SUPPLEMENTAL FINAL ENVIRONMENTAL
IMPACT STATEMENT

ALBANY PORT DISTRICT COMMISSION
PORT OF ALBANY EXPANSION PROJECT

TOWN OF BETHLEHEM, NEW YORK

Date: February 2022

Figure 2.3-1:

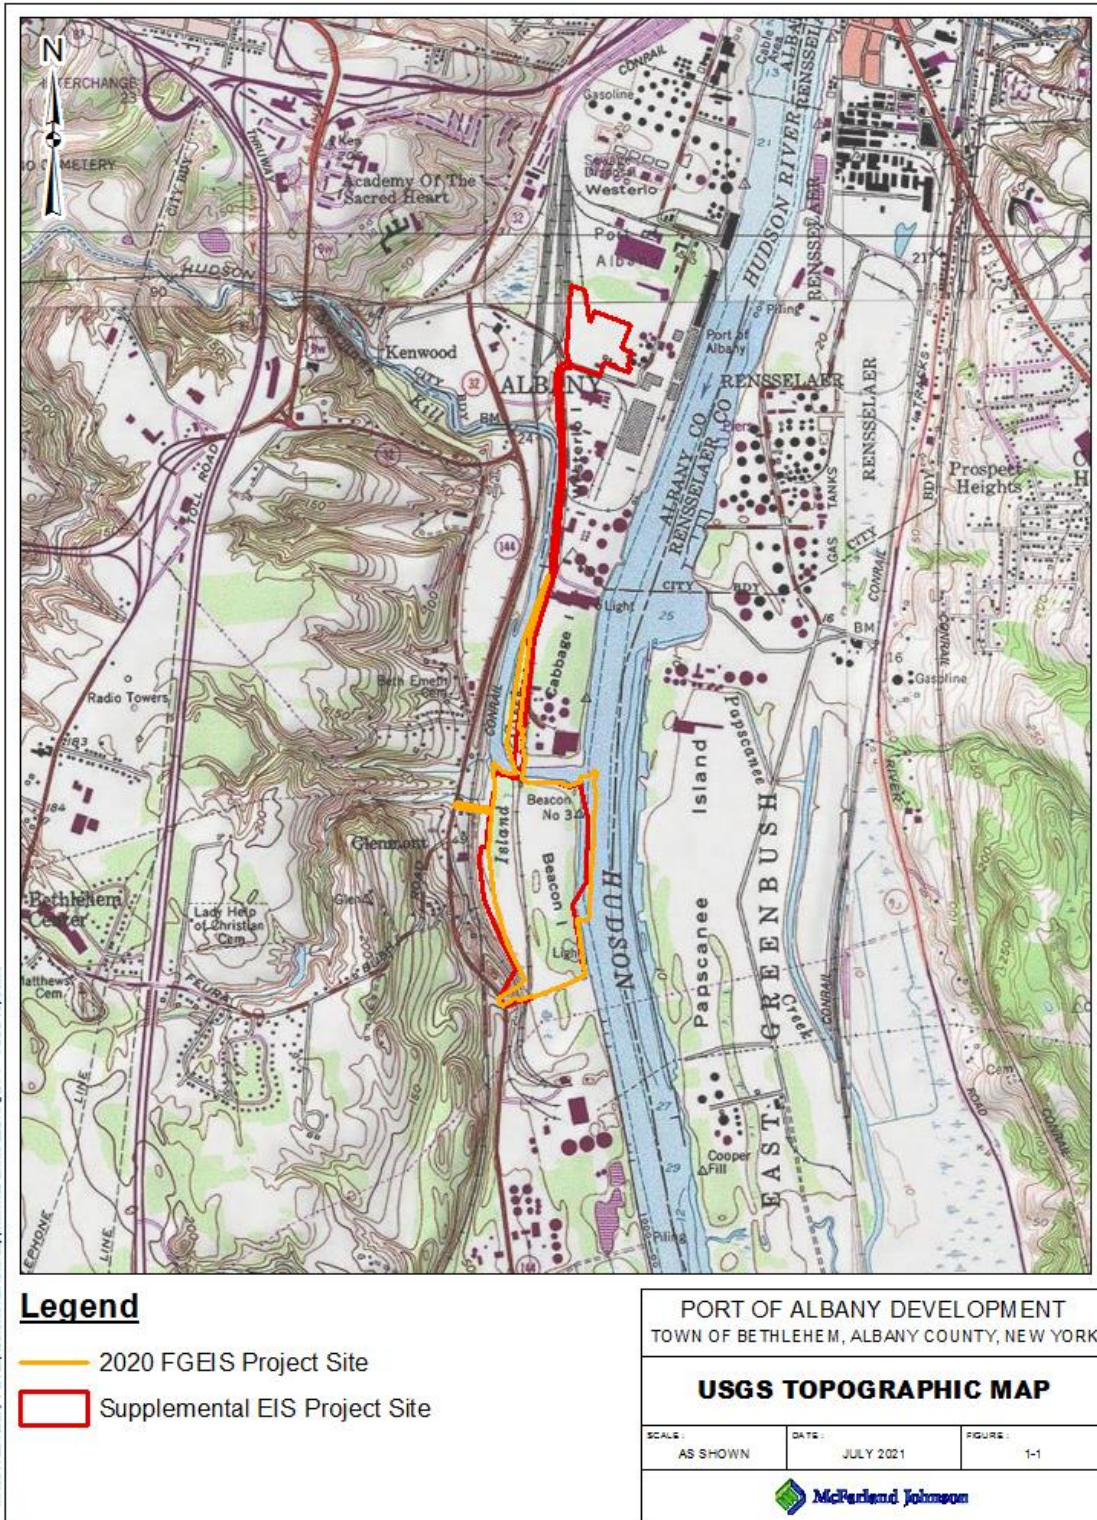
Comment A-3: Figure 2.3-1, and similar figures throughout the SDEIS, are confusing, especially where the 2020 Final GEIS Project Site line and Supplemental EIS Project Site line are depicted within the Hudson River. Based on the figure, it appears that the Supplemental EIS Project Site includes some but not all the area in the Hudson River, however, the SDEIS includes statements like, “supplemental Project Areas do not include any lands under water” and “the supplemental Project Area is not located within or adjacent to the Hudson River.” These discrepancies should be clarified in the Supplemental Final Environmental Impact Statement (SFEIS), including updated figures, if necessary.

Figure 3.20-1 Potential Environmental Justice Areas in the City of Albany (South)

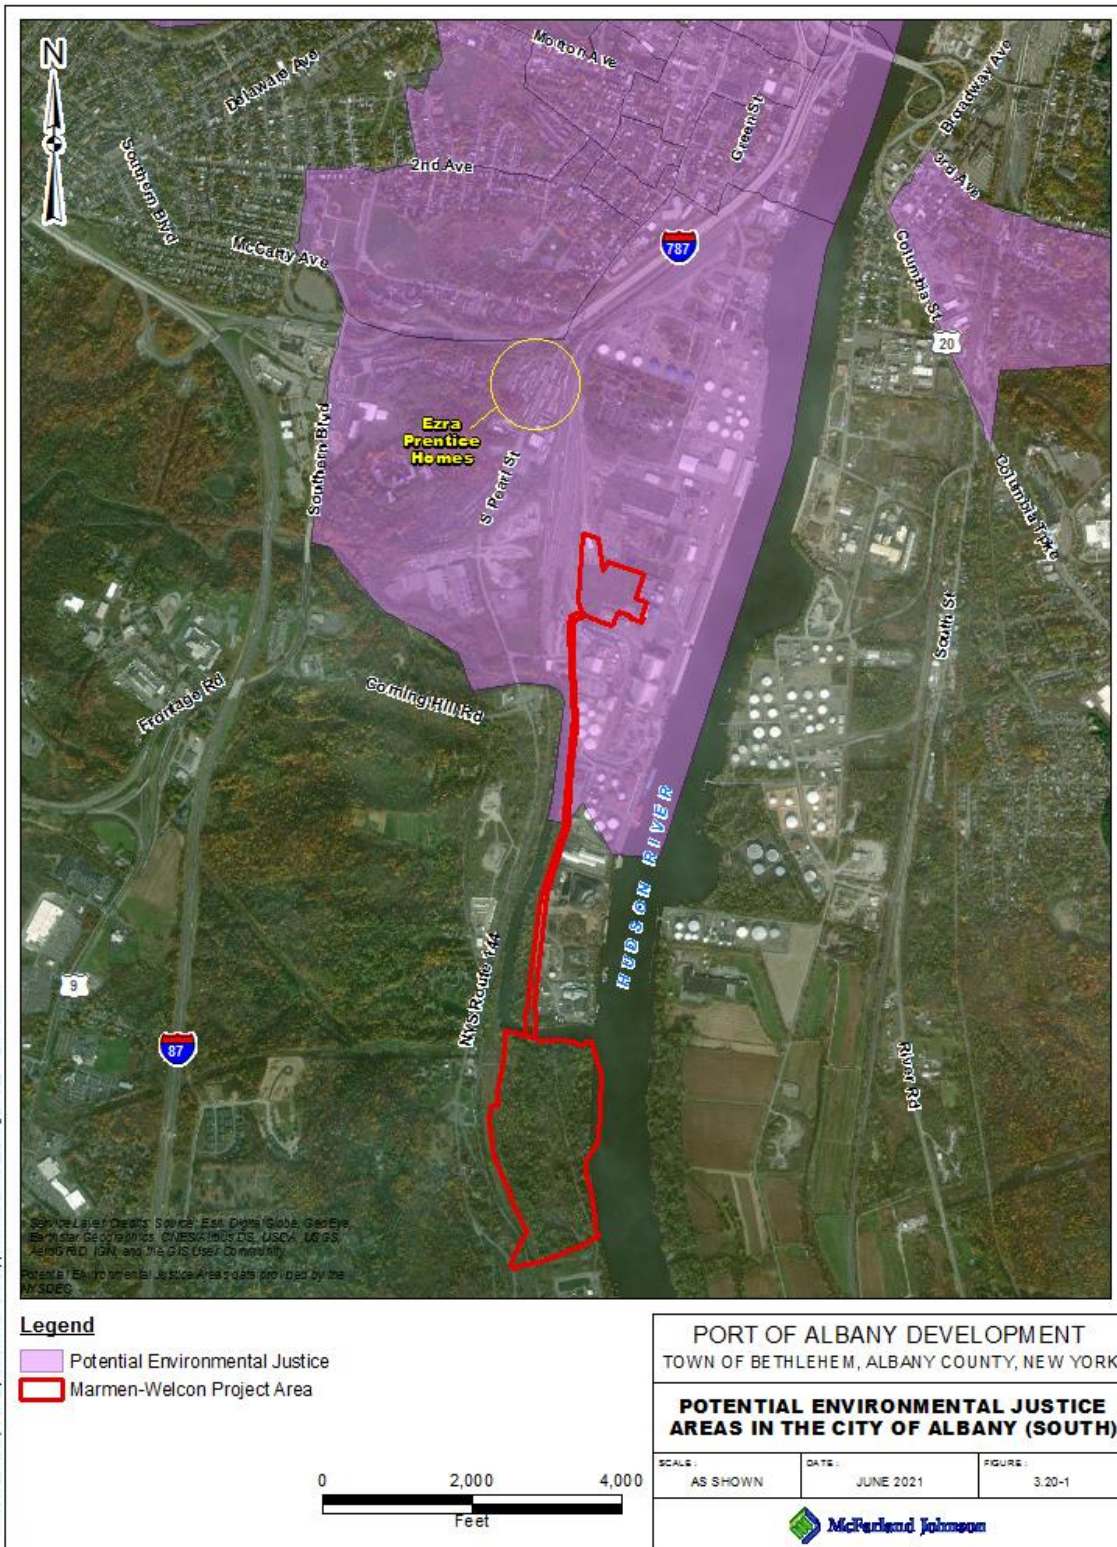
Comment A-1.15 and A-1.16: (Page 18 and Page 20) The Potential Environmental Justice Area (PEJA) Maps should be used. The PEJA area includes Ezra Prentice and extends south of it. The PDF – Supplemental EIS 2021 –10—27-4 final displays the PEJA map in Figure 3.20-1.

Figure 1.4.6-1: AERMOD 5 km Modeling Domain and Receptor Grid (Including 17 Discrete Receptors Representing Ezra Prentice)

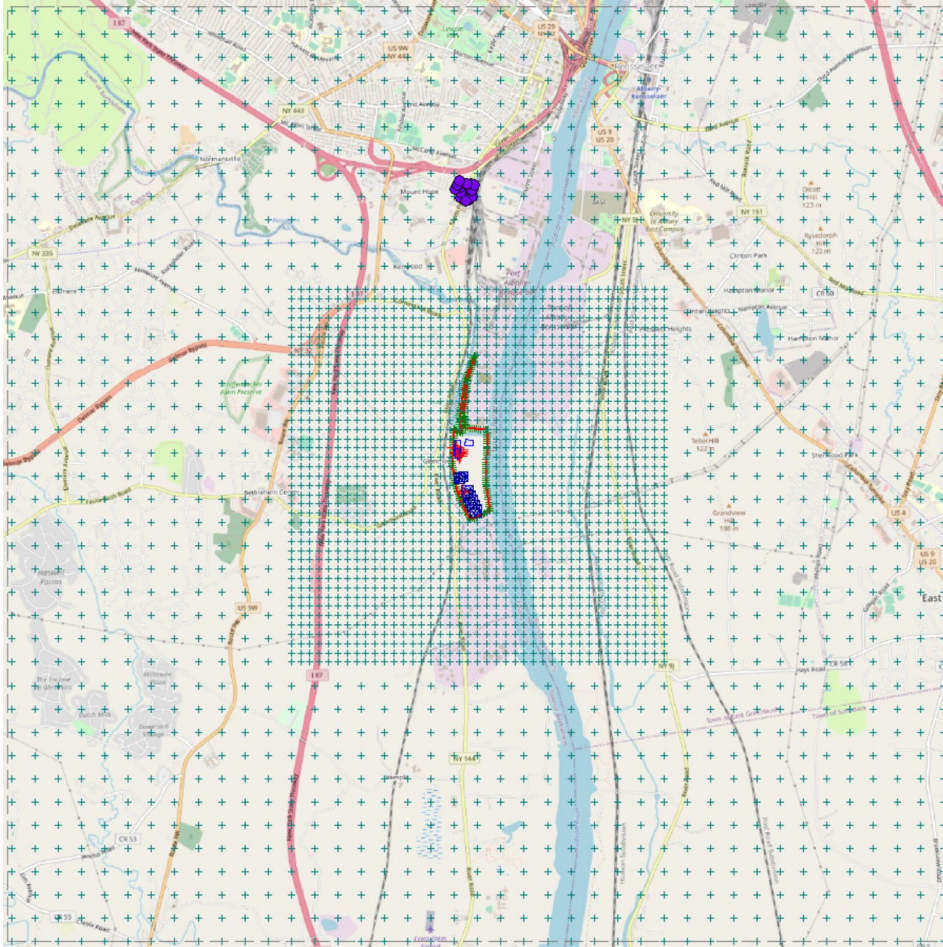
Commented [NYSDEC15]: When the air application is submitted, it must include a protocol outlining the steps taken to model offsite concentrations if AERMOD is going to be applied. The protocol should include the details of the criteria pollutant modeling in addition to the non-criteria. If AERMOD is to be used, the protocol needs approval by NYSDEC before the modeling details are submitted.

Figure 1.4.6-2: Location of EJ Area (Ezra Prentice) Relative to the Project

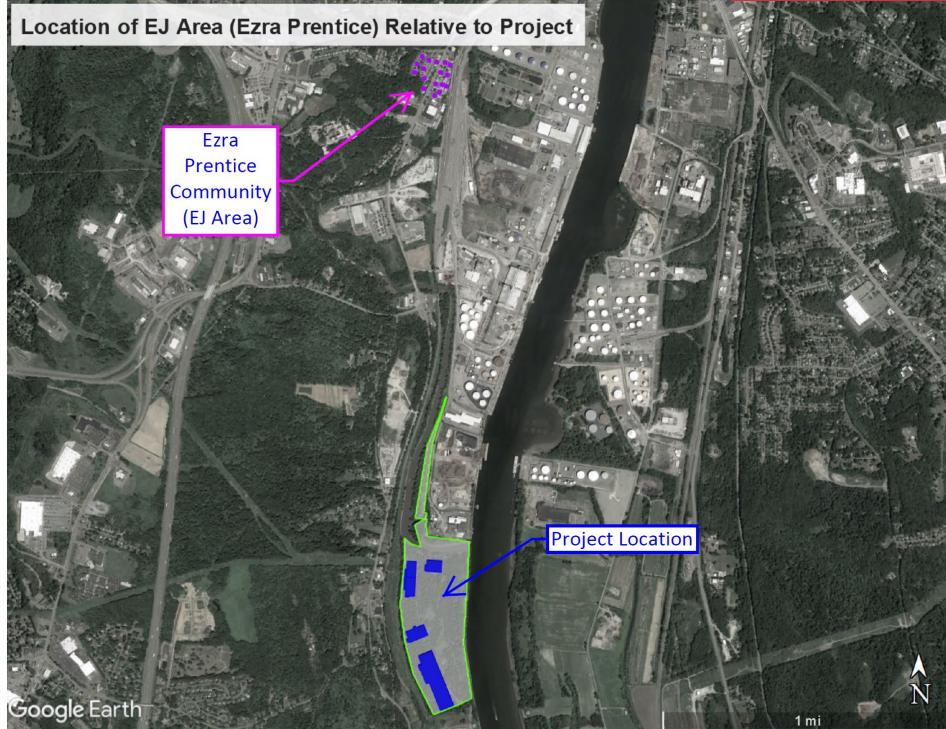
Commented [NYSDEC17]: The Potential Environmental Justice Area (PEJA) Maps should be used. The PEJA area includes Ezra Prentice and extends south of it. The PDF – Supplemental EIS 2021 –10—27-4 final displays the PEJA map in Figure 3.20-1.
